Re: Paric Corporation Project No. 15051
15051-Webster University Interdisciplinary Science Building
CP-080 - ASI#44 - Automatic Door Opener Revisions per Webster

PROJECT MANAGEMENT - CHANGE ITEM DETAIL REPORT

15051 - 15051-Webster University Interdisciplinary Science Building

SHEET E0101.A LEVEL 01 AREA A FLOOR PLAN – ELECTRICAL & AUXILIARY

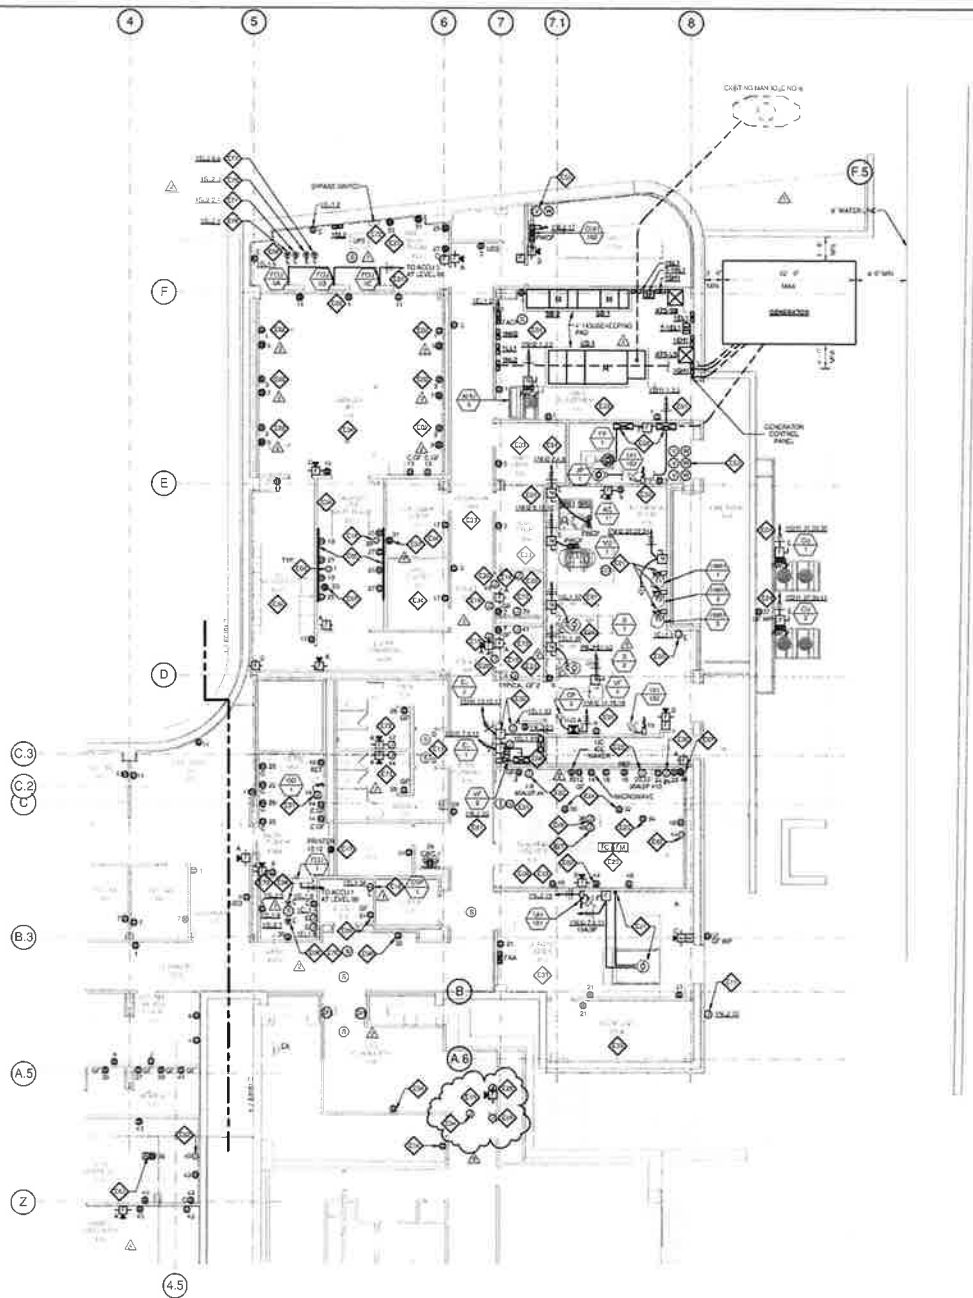
- In EAB Connector 150, provide motorized door opener to serve door 150 and connect to existing circuit serving area.

SHEET E0102.A LEVEL 02 AREA A FLOOR PLAN – ELECTRICAL & AUXILIARY

- In EAB Connector C270A, provide motorized door opener to serve door XC270A.1 and connect to circuit 46 serving adjacent door.
